CITY OF SEASIDE
BOARD OF ARCHITECTURAL REVIEW

REGULAR MEETING
COUNCIL CHAMBER
440 Harcourt Avenue
Wednesday, April 4, 2018
5:30 PM

- A. BOARD OF ARCHITECTURAL REVIEW APPLICATION NO. BAR -17-15. ARTHUR NOBIDA, PROPERTY OWNER AND APPLICANT, IS REQUESTING DESIGN REVIEW APPROVAL FOR A SECOND STORY ADDITION TO AN EXISTING ONE-STORY SINGLE FAMILY RESIDENCE LOCATED AT 1739 YOSEMITE STREET IN THE SINGLE FAMILY RESIDENCE LOCATED AT 1739 YOSEMITE STREET IN THE SINGLE FAMILY RESIDENTIAL (RS-8) ZONING DISTRICT (APN 012-101-065). THIS PROJECT IS CATEGORICALLY EXEMPT CLASS 1, SECTION 15301.EA, EXISTING FACILITIES, FROM THE CALIFORNIA ENVIRONMENTAL QUALITY ACT. THIS ITEM WAS CONTINUED FROM THE FEBRUARY 21, 2018 BOARD OF ARCHITECTURAL REVIEW MEETING.**

WALL LEGEND
EXISTING WALL TO REMAIN
NEW WALL, 2X4 @ 16" O.C. U.O.N.

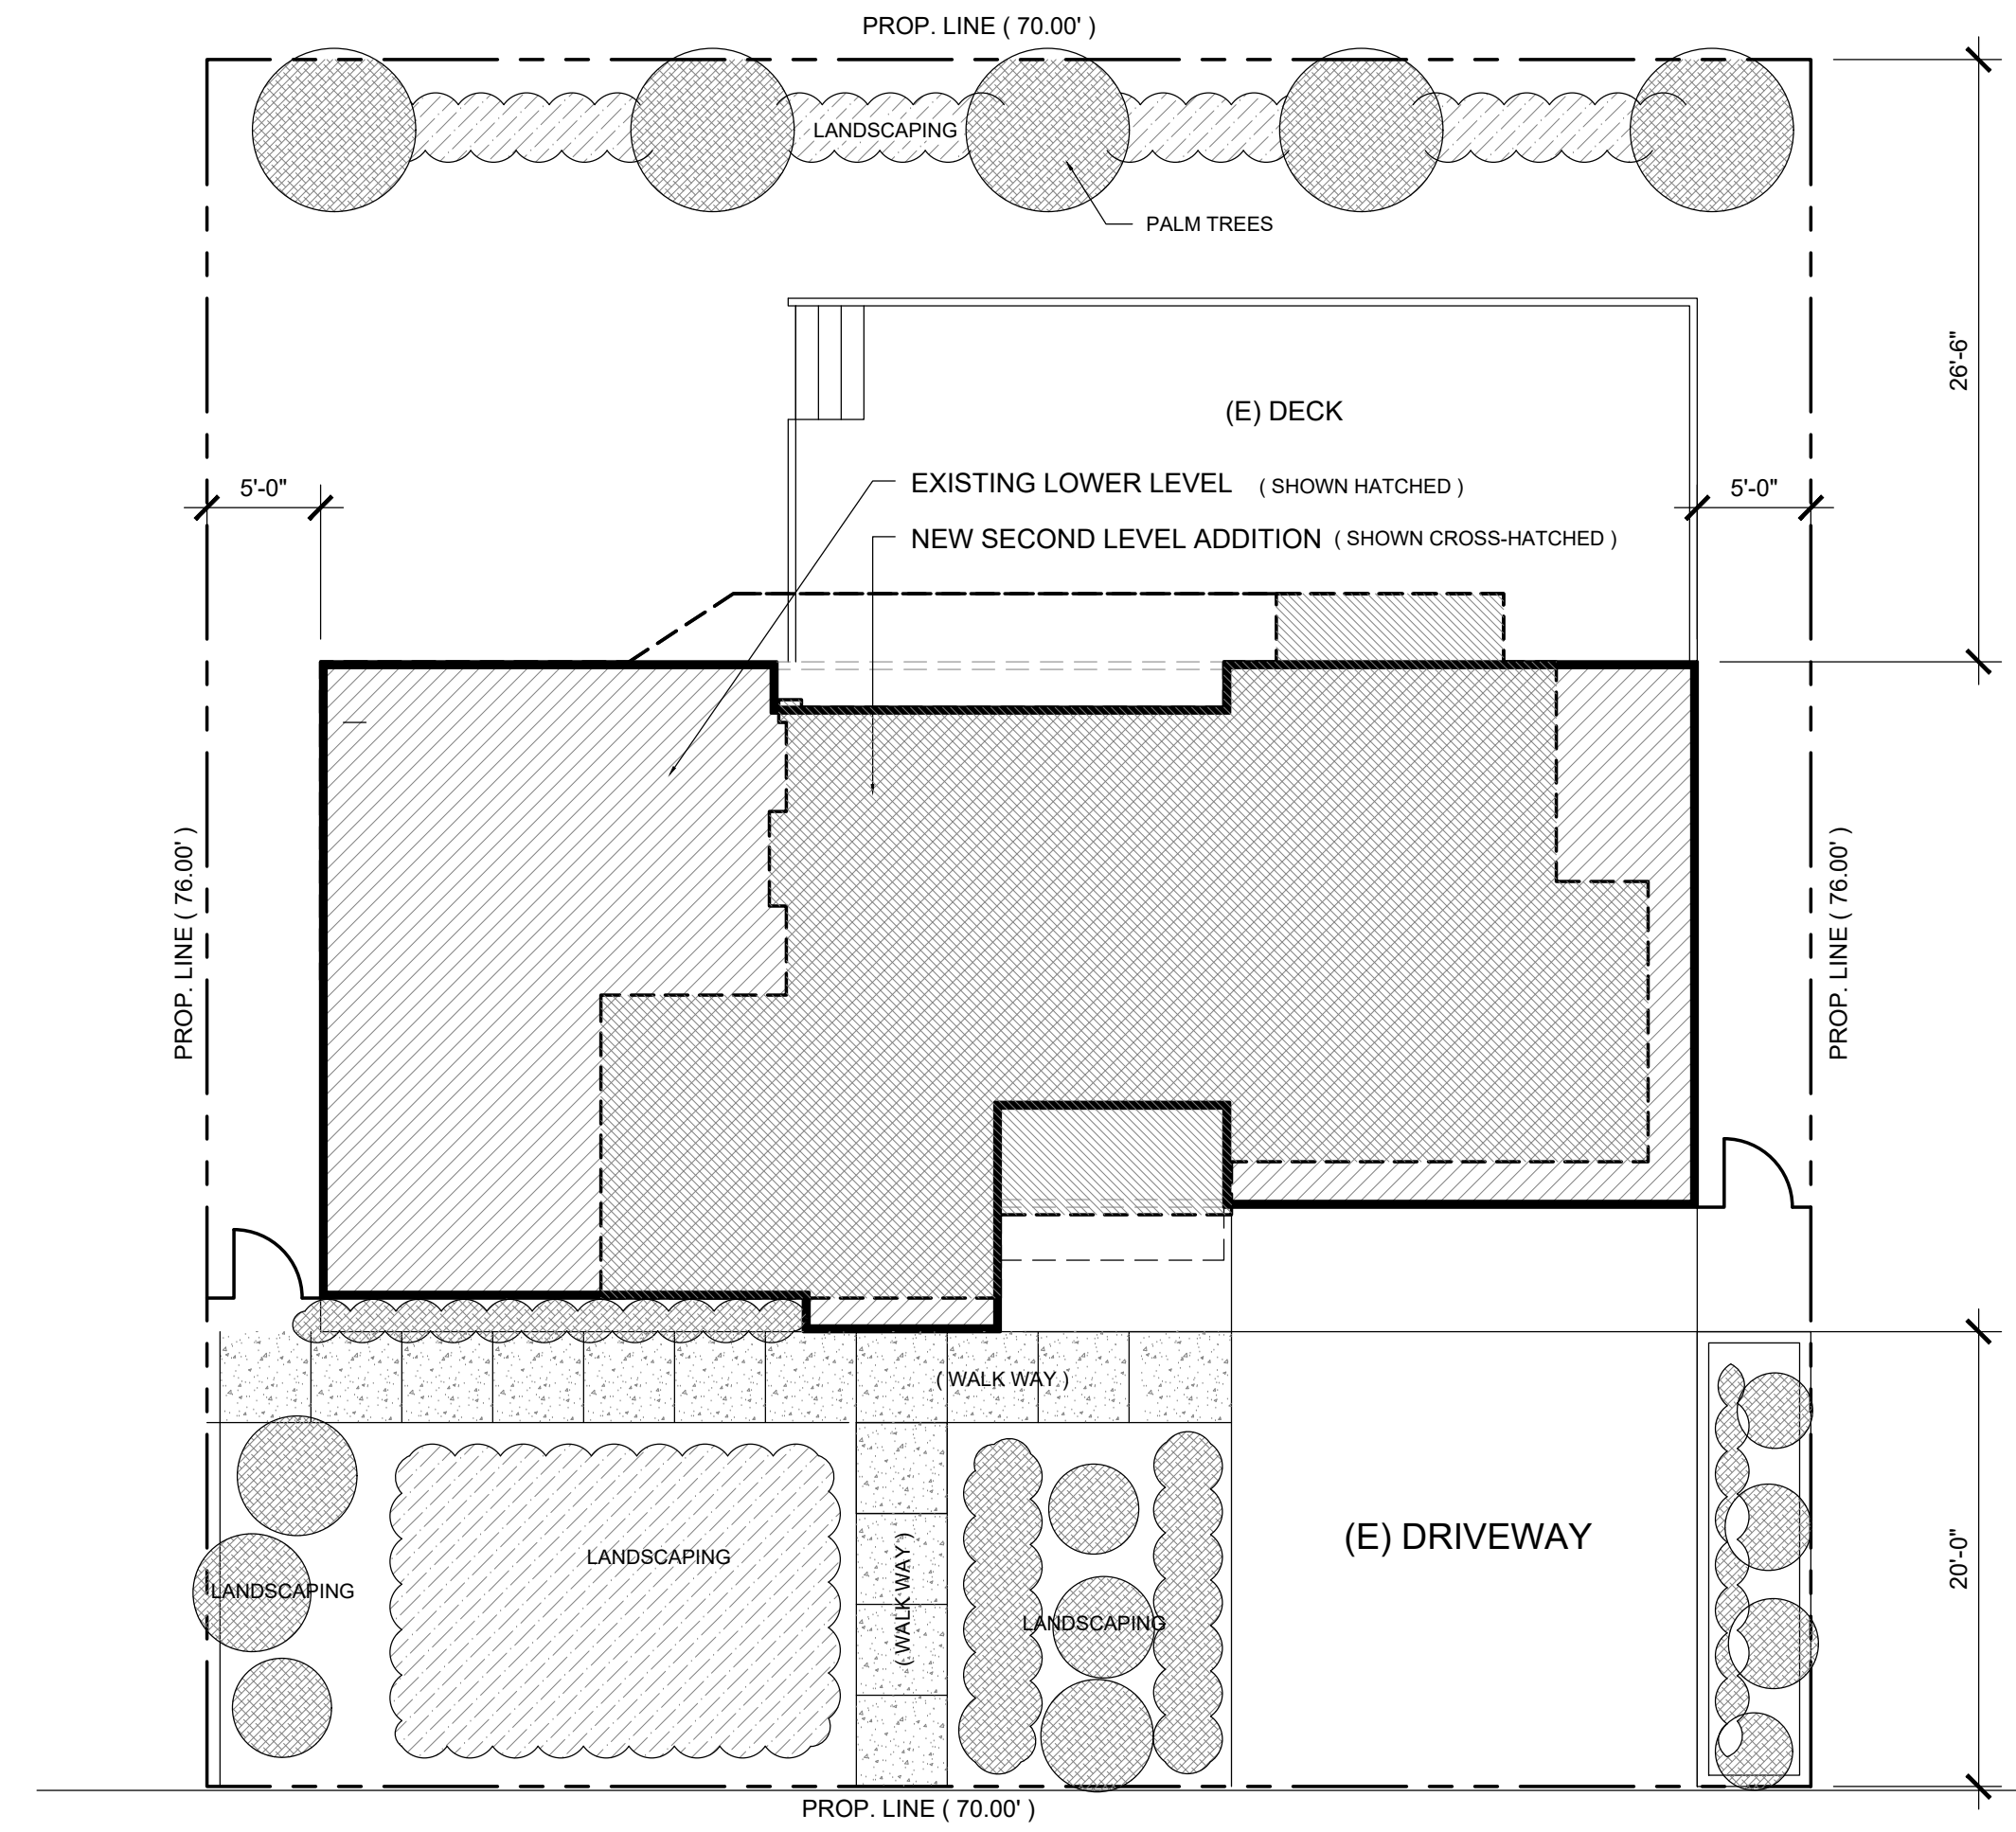
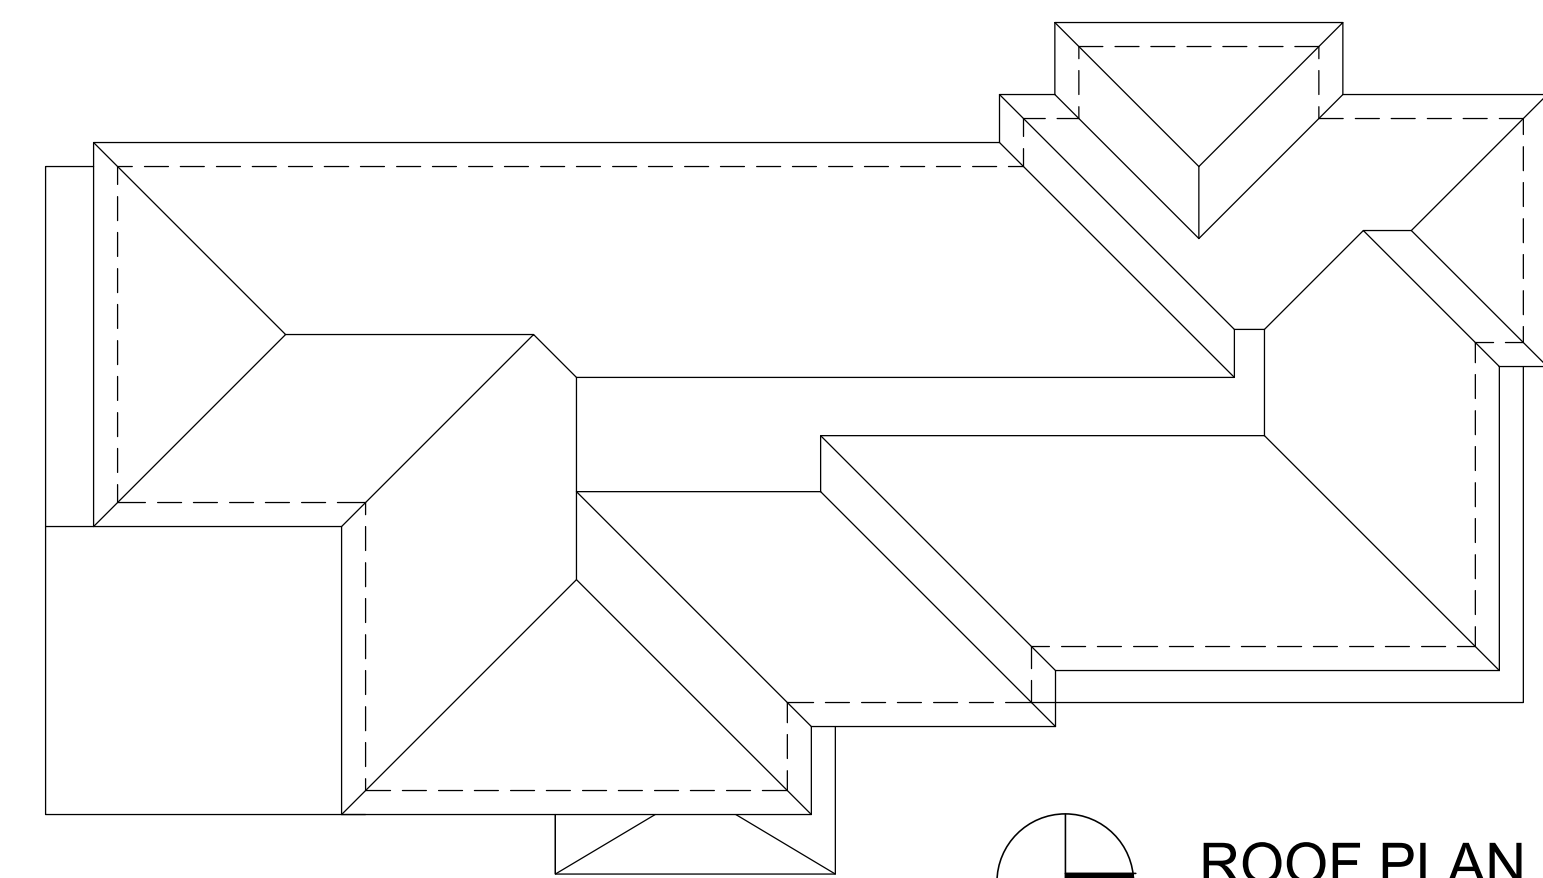
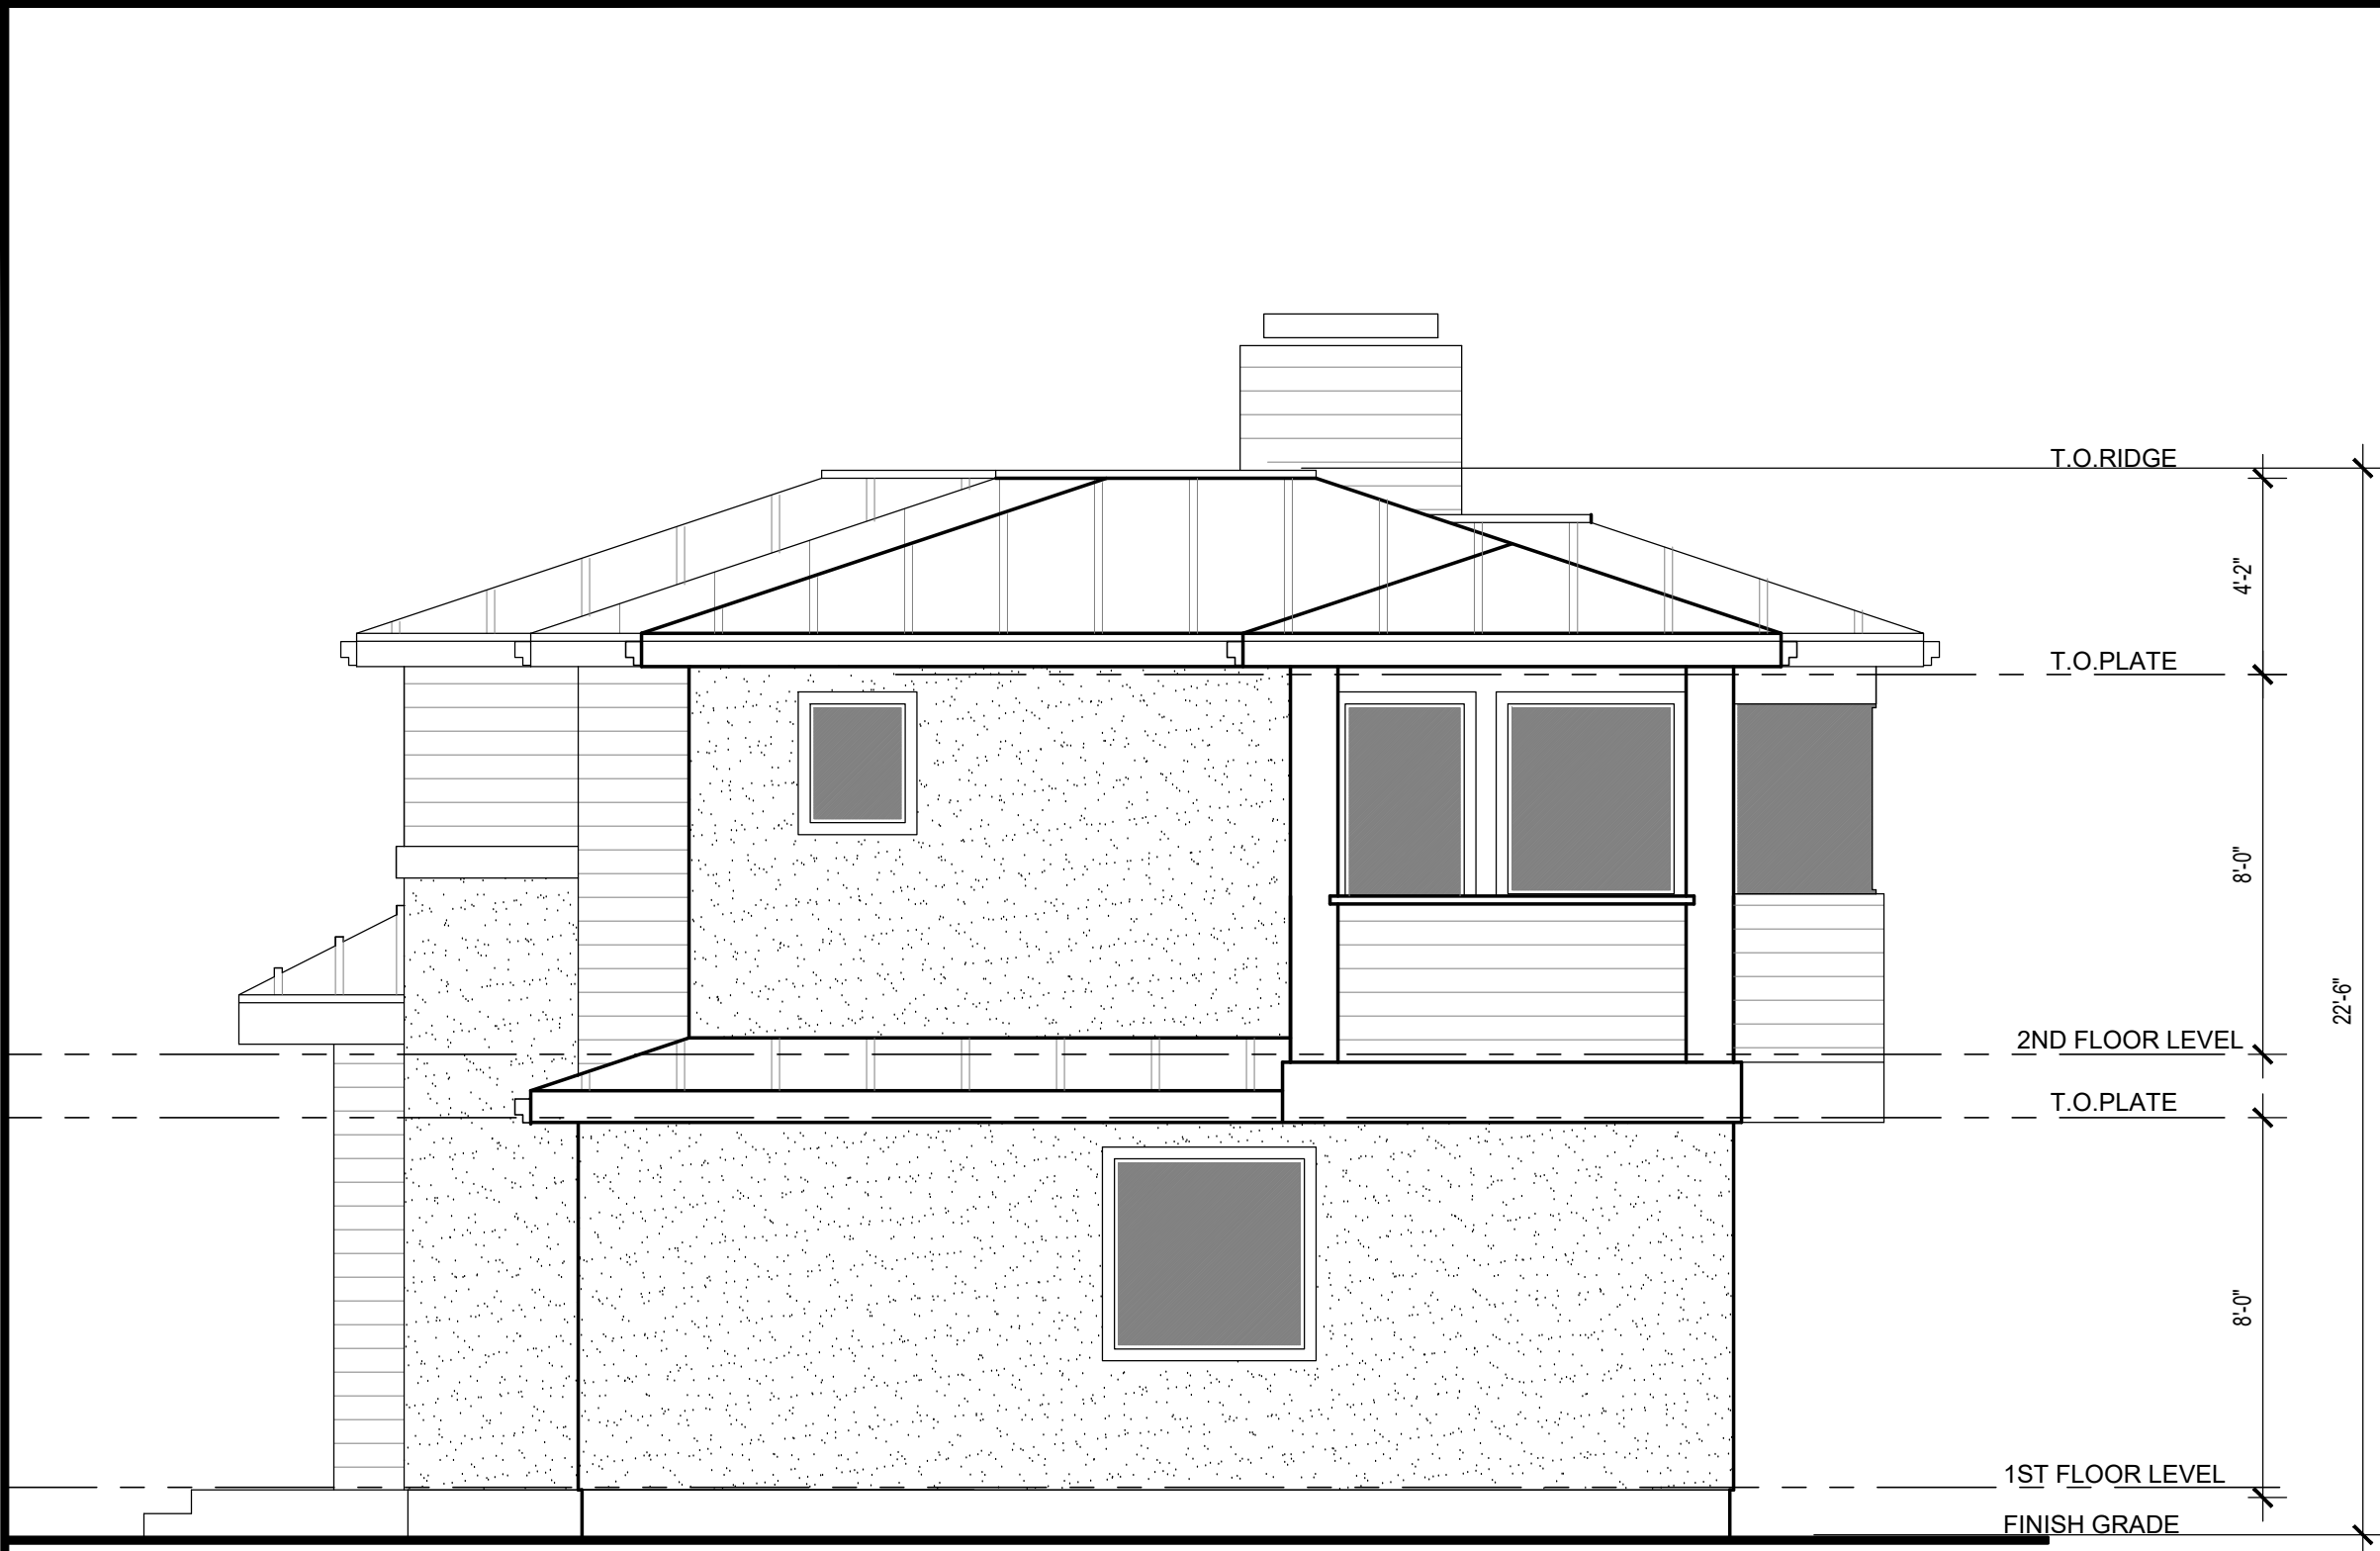
- Consider lowering the 9 foot plate height of the second story.
- Consider modifying the architectural design of the second story element to provide setbacks from the first story.
- Cut back the roof that extends over the second story deck off of the Great Room.
- Review enlarging the front entrance and match this roof to the rest of the house.

The BAR had concerns with the amount roof area being added, substantial second story building offsets from the first floor footprint and the lack of a cohesive entry feature over the front door. The BAR must evaluate the changes to determine if the design modifications made to the proposed project will provide a design which not only meets the minimum design standards but will also provide a cohesive design to blend with the neighborhood.

- 1) Lowered ridge line of roof from 23'5" to 22'6"
- 2) Created flat sections of roof
- 3) Plate height Lowered from 9' to 8'
- 4) Downsized roof width 2' on north and 2' on south side for a total of 4'
- 5) Provided set back of north/east side of 2' over garage
- 6) Shortened height of master bedroom bay window and now frameless
- 7) Front door added hip to match house roof
- 8) Plant 5 Queen Palm trees across backyard property line for neighbors' privacy

- 9) Downsized deck off master bedroom and all wood siding for railing
- 10) Downsized master bedroom and master bathroom shower
- 11) Added window in bathroom facing west
- 12) Added bbq area on south side of deck
- 13) Wood siding for south side of deck
- 14) Changed to vinyl casement windows
- 15) Added wood siding to west side center and larger window at bar
